Improved Technical Specifications

Quad Cities Station

Volume 5:
Sections 3.4 and 3.5

Figure 3.4.9-1 (Page 1 of 1)
Non-Nuclear Inservice Leak and Hydrostatic Testing Curve
(Valid to 32 EFPY)

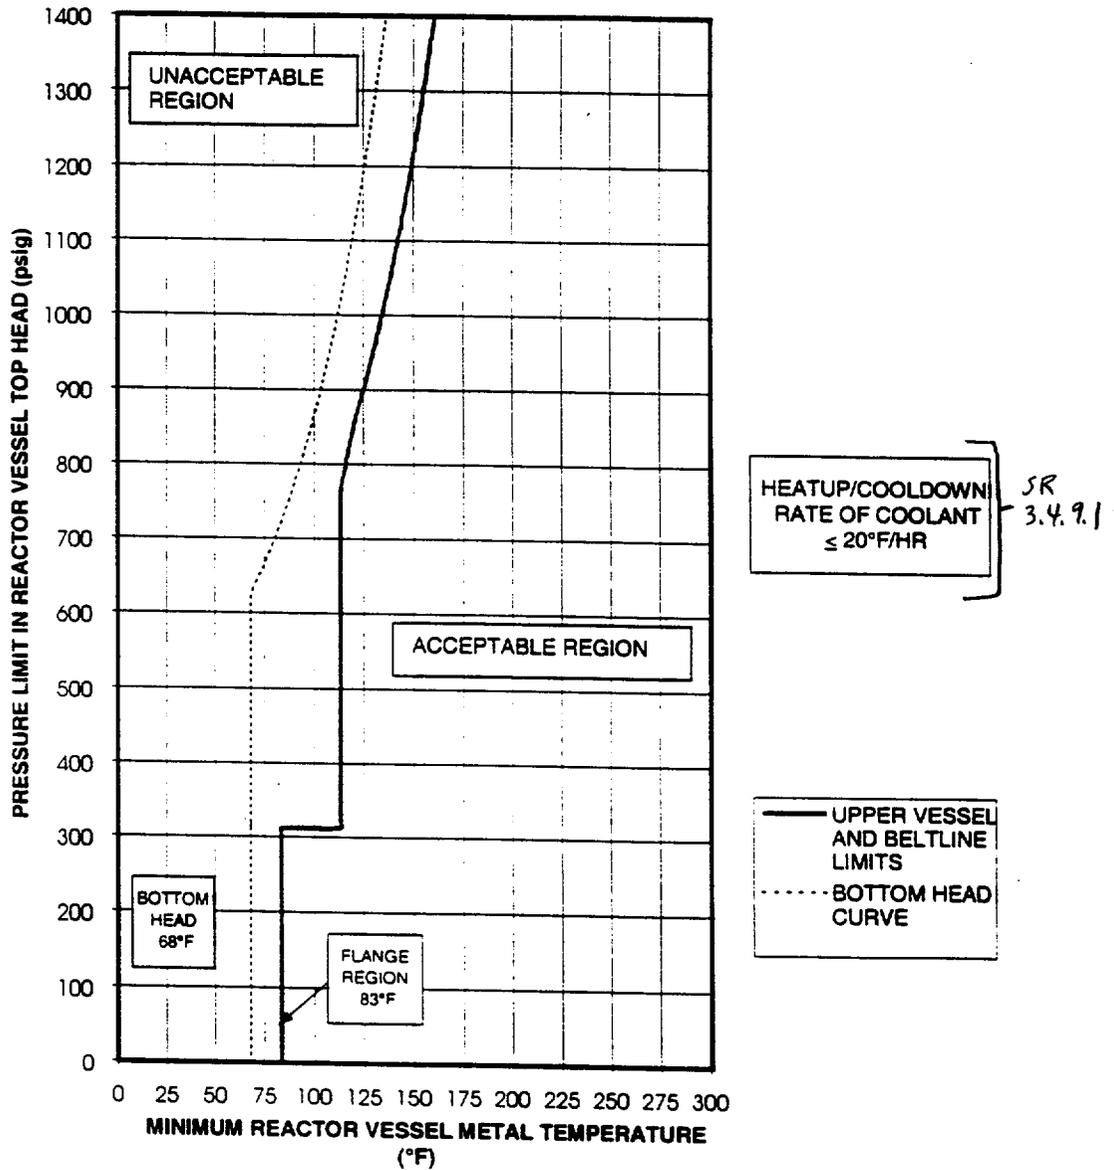
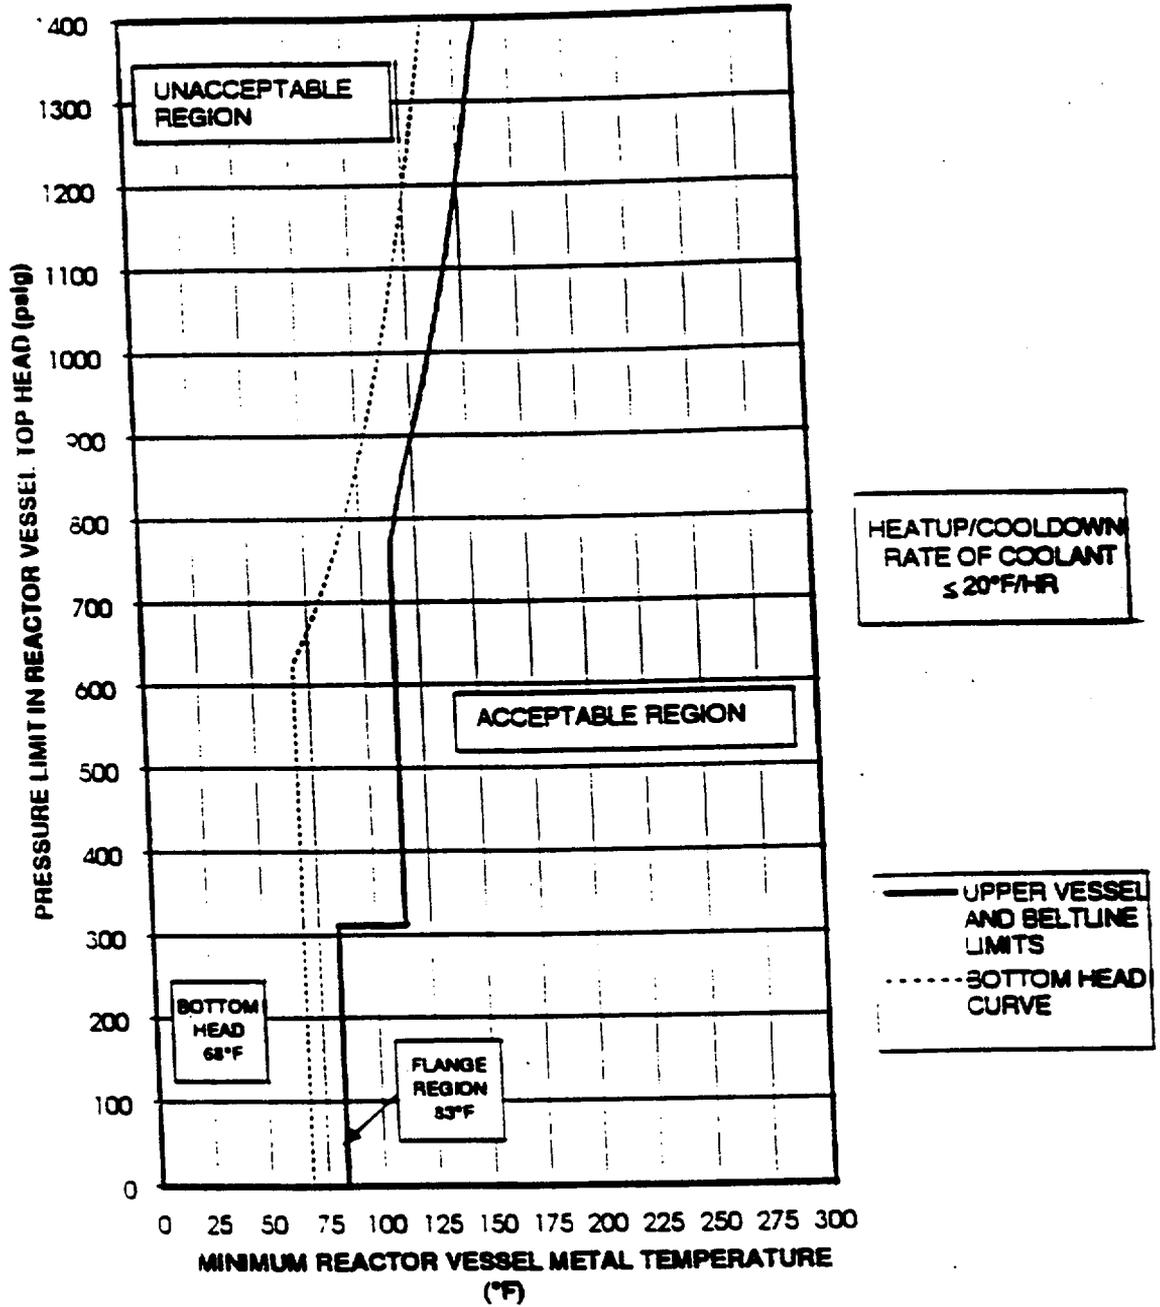
Insert Figure 3.4.9-1

<Fig. 3.6.K-1>

Figure 3.4.9-2 (Page 1 of 1)
Non-Nuclear Heatup/Cooldown Curve
(Valid to 32 EFPY)

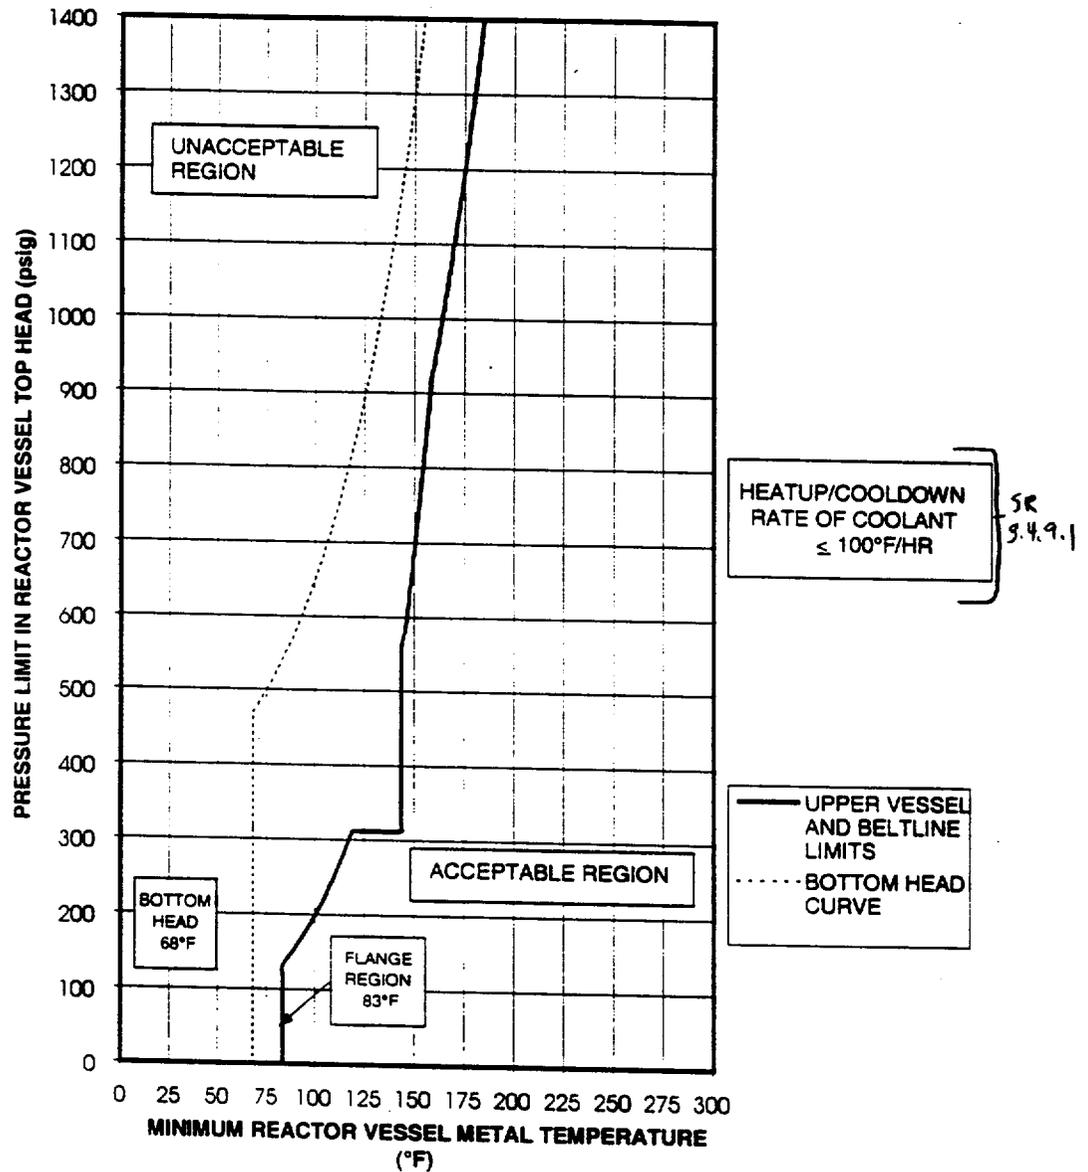
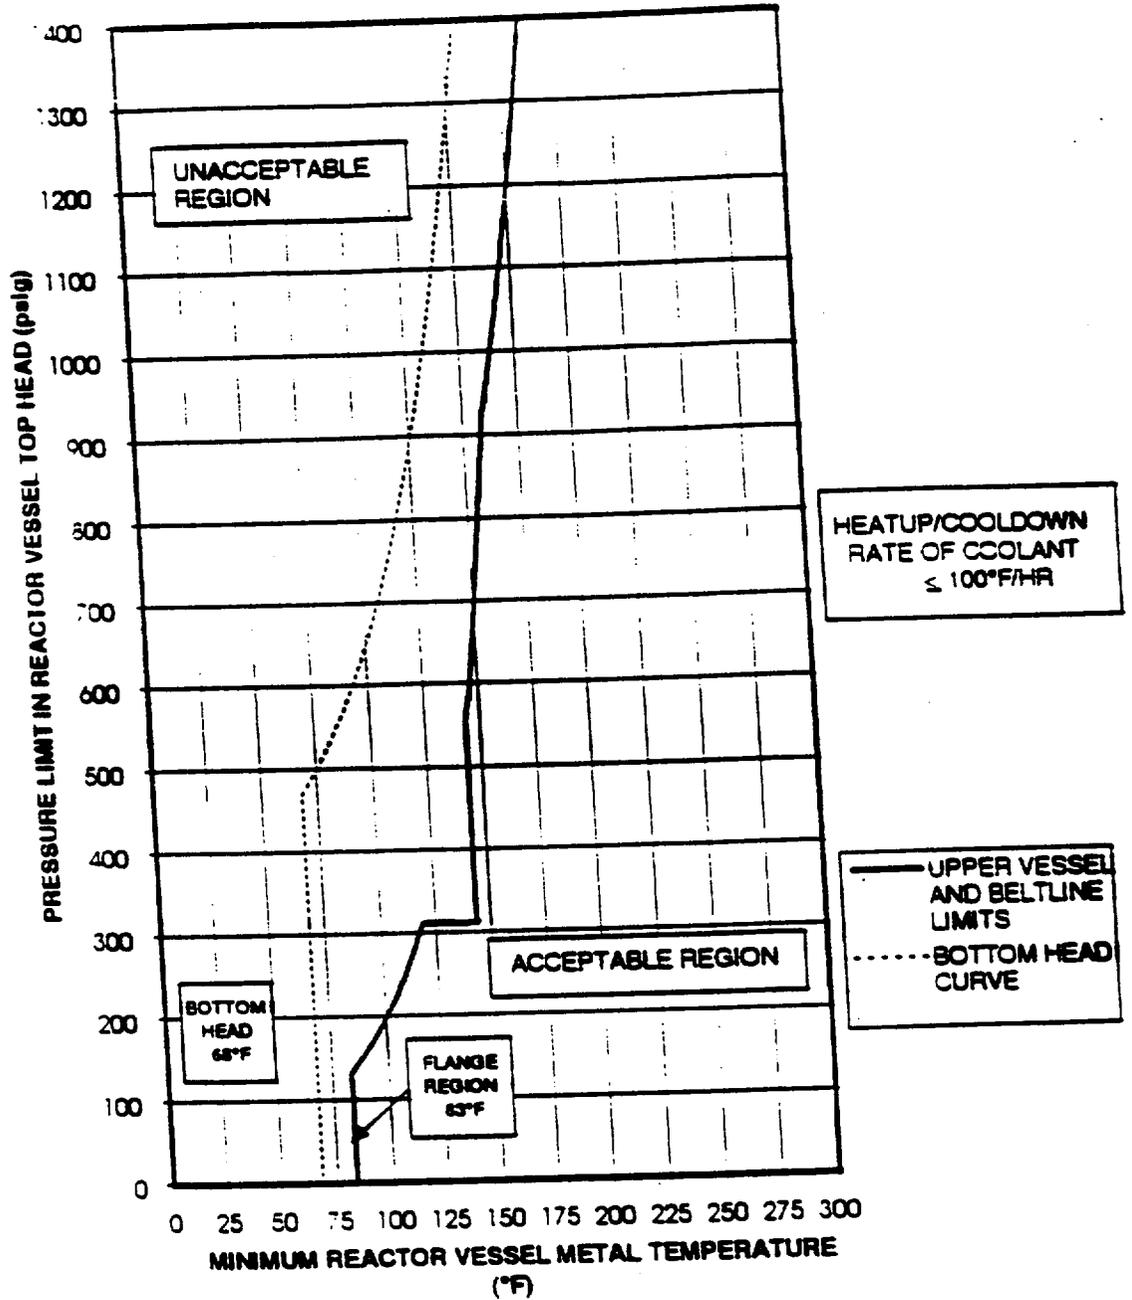
Insert Figure 3.4.9-2

<Fig 36.K-2>

Figure 3.4.9-3 (Page 1 of 1)
Critical Operations Curve
(Valid to 32 EFPY)

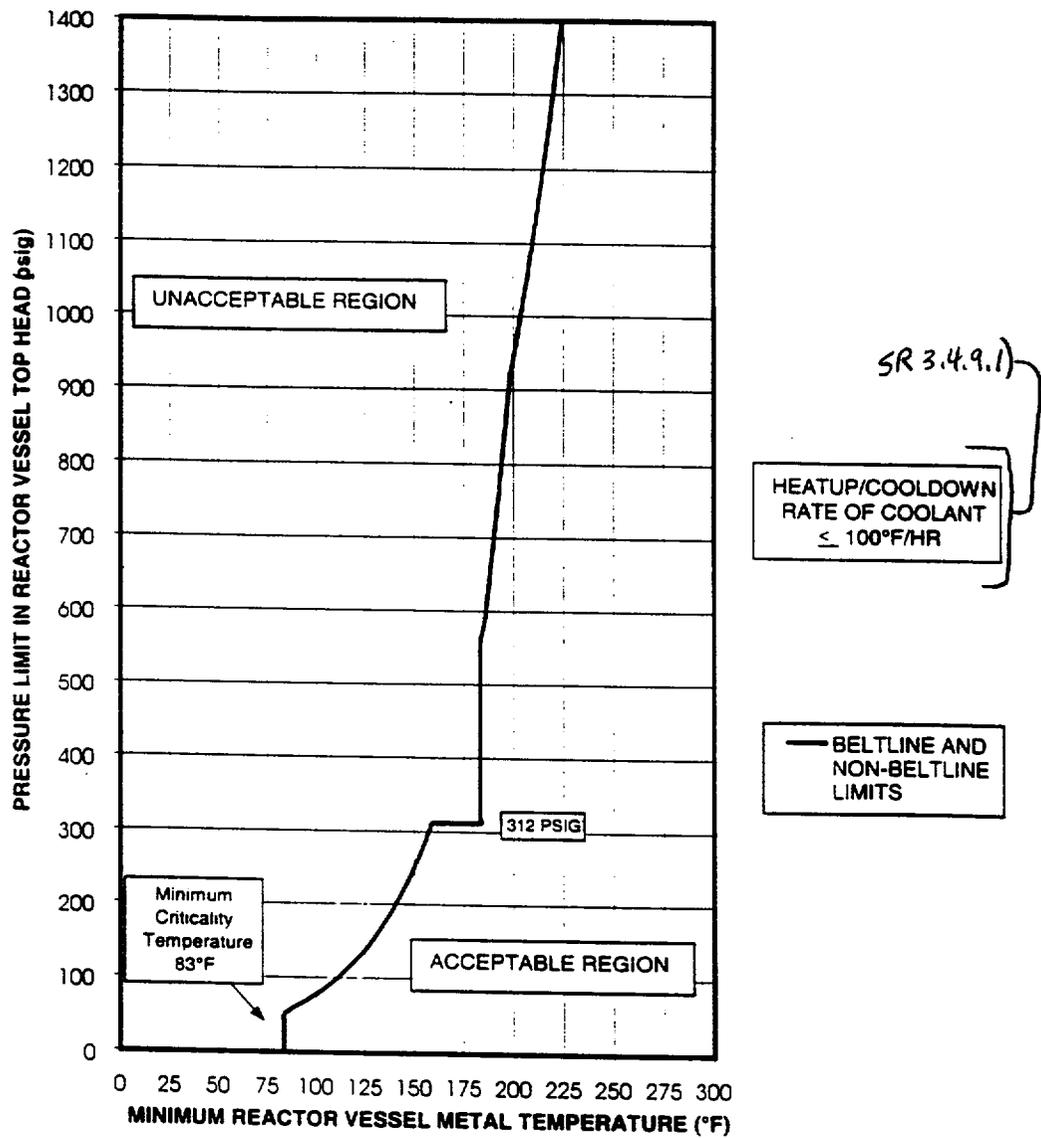
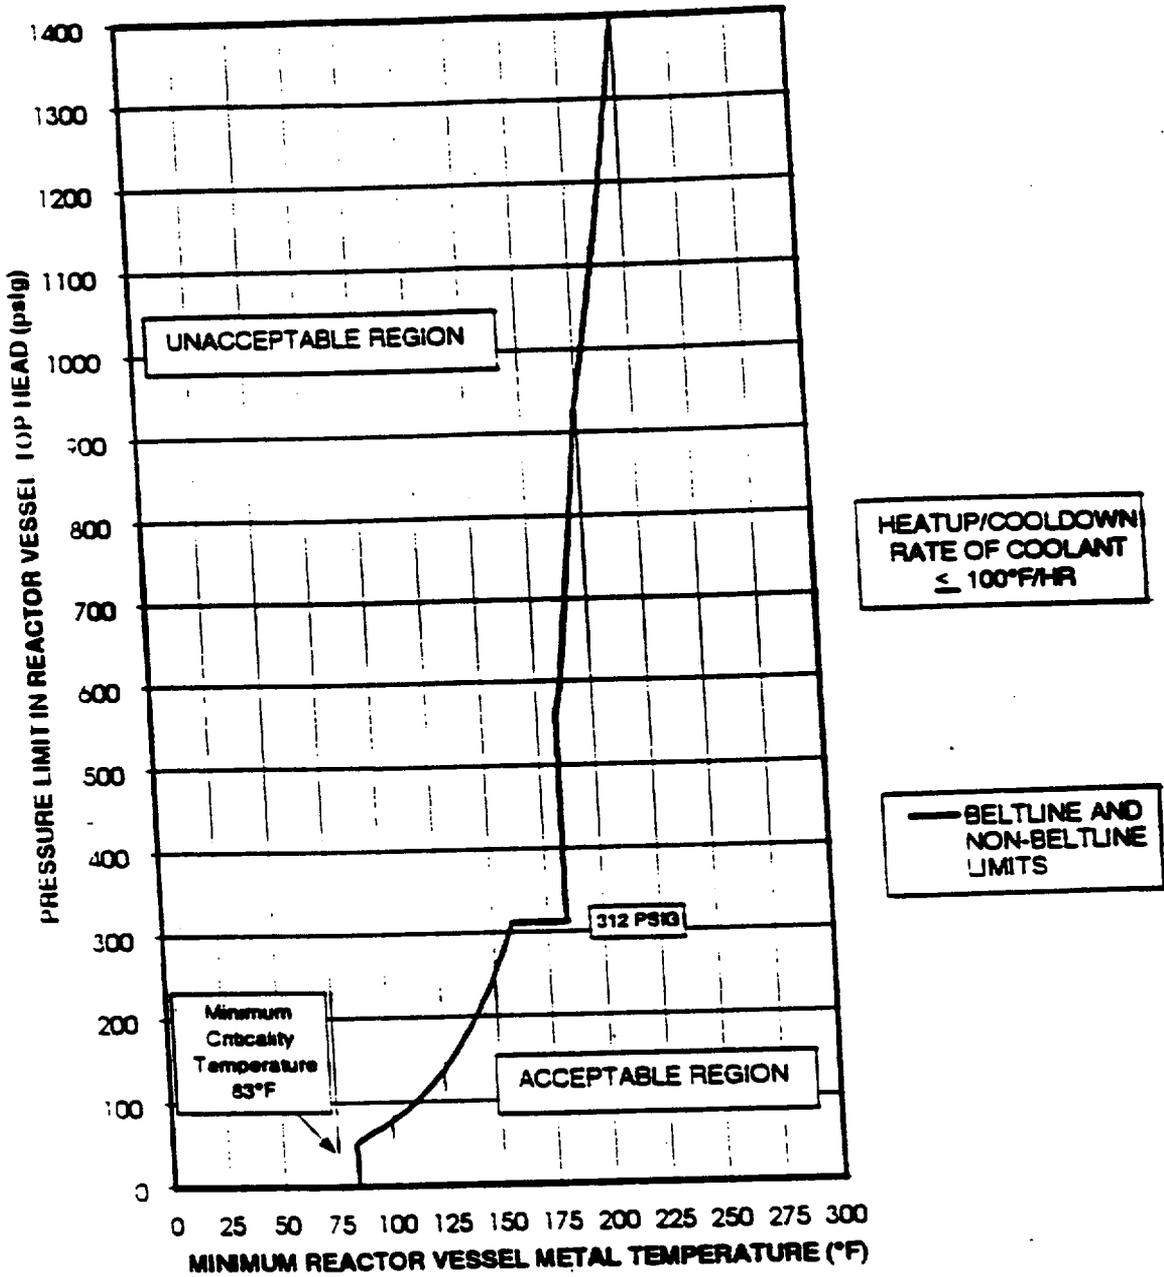
Insert Figure 3.4.9-3

(Fig 3.6.K-3)
